CORPORATION OF THE TOWNSHIP OF ESQUIMALT

Staff Report

Report No. DRC-21-004

Official Community Plan Amendment and Rezoning Application - 819 Esquimalt Road (including 821 and 823 Esquimalt Road)

re-issue no: **2** sheet no: **A0.7**

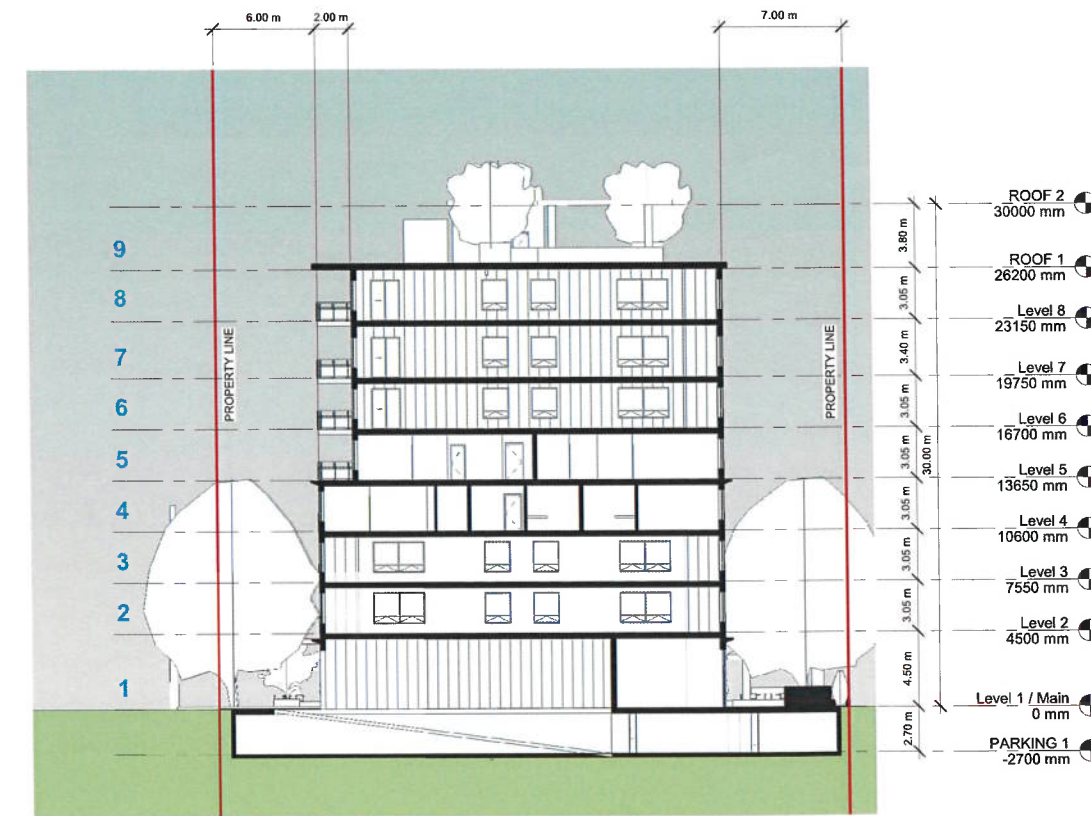
Staff note that the height of the building is unexpectedly high due to the design choice of including a covered pergola on the roof which must be accommodated in the height calculation (Appendix A, sheet A0.7).
